## 2 SITE CHARACTERISTICS AND SITE PARAMETERS

This chapter of the safety evaluation report (SER) documents the U.S. Nuclear Regulatory Commission (NRC) staff's review of Chapter 2, "Site Characteristics and Site Parameters," of the Tennessee Valley Authority (TVA's or the applicant's), Construction Permit Application (CPA), Preliminary Safety Analysis Report (PSAR). TVA submitted this CPA for a single unit, small modular reactor (SMR) plant at the Clinch River Nuclear (CRN) Site located in Oak Ridge, Roane County, Tennessee. The PSAR is based on the proposed construction of a one-unit BWRX-300 SMR (hereinafter referred to as CRN-1) designed by GE-Vernova Hitachi Nuclear Energy (GVH) with a nominal electrical output of 300 MWe. The staff's regulatory findings documented in this SER are based on Revision 1 of the TVA CPA PSAR, dated April 9, 2026 (Agencywide Documents Access and Management System [ADAMS] Accession No. ML26119A628). The staff reviewed Chapter 2 of the TVA CPA PSAR, as supplemented, against applicable regulatory requirements using regulatory guidance and standards to evaluate the adequacy of site characteristics and site parameter information with respect to the preli

**Figure 2-1 Comparison of TVA's 1 Hz mean rock hazard curve (blue line) with the staff's 1 Hz mean rock hazard curve (red line).**

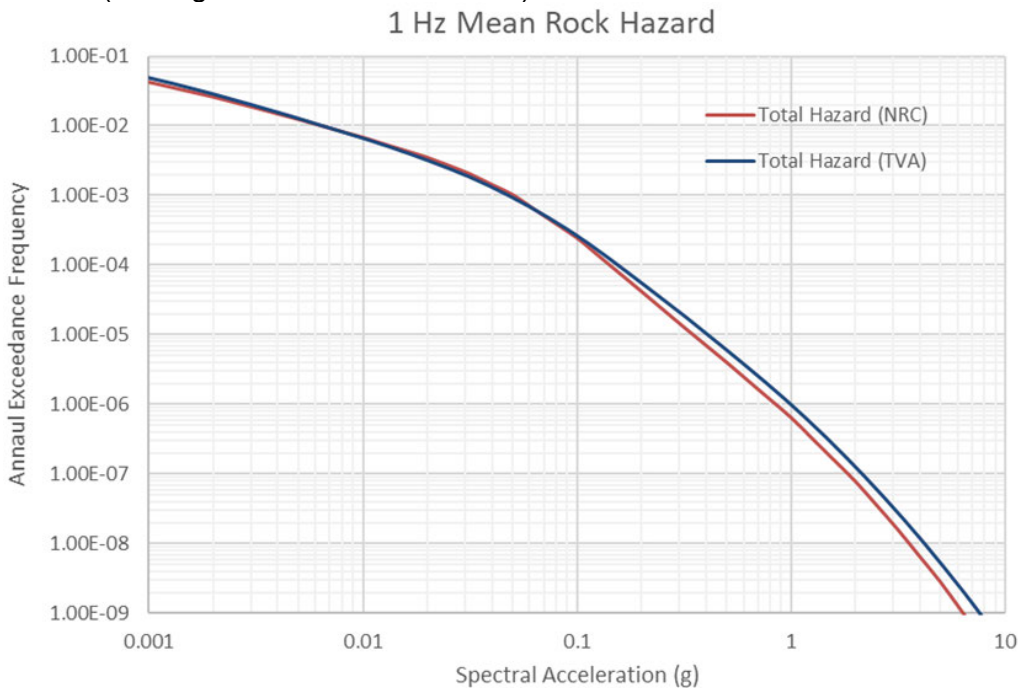
In response to audit question A-2.5.2-18, the applicant performed a sensitivity study to justify retaining a weight of 0.5 for the Ramos-Sepulveda et al. (2024) adjustment factors in its PSHA calculations, rather than re-calculating the hazard. The applicant determined that applying a weight of 0.5 to the Ramos-Sepulveda et al. (2024) adjustment factors resulted in a reduction in ground motions of up to approximately 16 percent (for AFEs ranging from  $10^{-4}$  to  $10^{-6}$ ) at frequencies greater than 0.5 Hz; at lower frequencies, this adjustment resulted in an increase in ground motions of up to 22 percent. In the critical frequency range of 1 to 10 Hz, the Ramos-Sepulveda et al. (2024) adjustment factors resulted in a reduction in ground motions of 13.5 percent at 10 Hz, which decreased to 6 percent at 1 Hz.

Based on the applicant's sensitivity analysis, the staff determined that applying a weight of 0.5 to the Ramos-Sepulveda et al. (2024) adjustment rather than re-calculating the hazard without the adjustment, is adequate because the percent increase in ground motion would be relatively small. Furthermore, as noted above, staff's confirmatory PSHA results are very similar to TVA's results (see Figures 2.5.2-1 and 2.5.2-2).

**Figure 2-3 Comparison of TVA's horizontal PBSRS (red curve) with the staff's horizontal PBSRS (light and dark blue curves).**

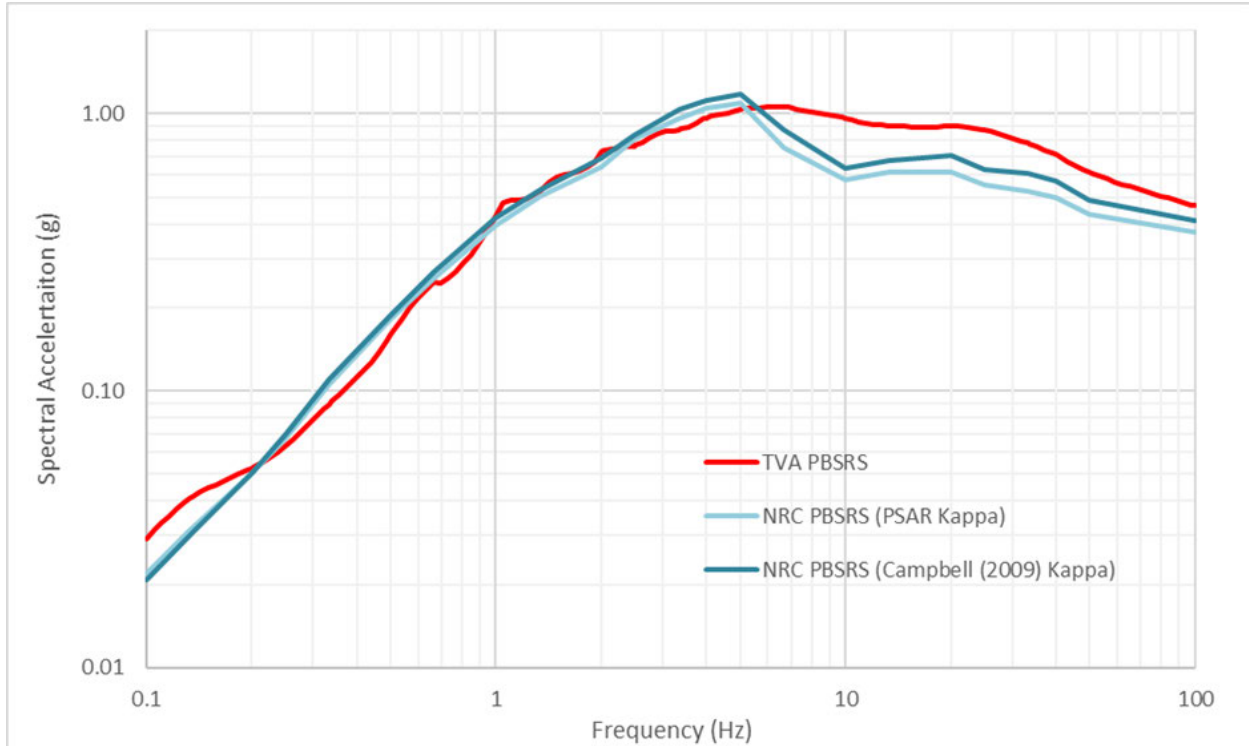
PSAR Section 2.5.2.5.8 states that the horizontal site-specific FIRS, PBIRS, and PBSRS are developed by scaling the respective  $10^{-4}$  site-specific mean UHRS by appropriate design factors as detailed in RG 1.208. To capture the characteristics of site amplification at spectral frequencies other than the 23 at which the PSHA is performed, the applicant interpolated the UHRS to 158 spectral frequencies between 0.1 and 100 Hz using the mean amplified spectral shapes available for each control point. The resulting horizontal FIRS, PBIRS, and PBSRS are provided in PSAR Figure 2.5.2-93R. PSAR Figure 2.5.2-95R provides the horizontal and vertical FIRS, PBIRS, and PBSR. As described in SE Sections 2.5.2.4 and 2.5.2.5, the staff performed a confirmatory PSHA and site response analysis and developed PBSRS using the performance-based approach outlined in RG 1.208. A comparison of the staff's PBSRS with TVA's PBSRS is shown in Figure 2.5.2-3. Despite the differences in rock hazard curve inputs (see Figures 2.5.2-1 and 2.5.2-3), as well as input MRD curves (as described in Section 2.5.2.5 of this SER), the results are similar. The staff notes that the staff's PBSRS is lower at frequencies above ~5 Hz, which is largely due to the applicant's use of a wider range of MRD curves. As such, the staff determined that the applicant's horizontal PBSRS is adequate.
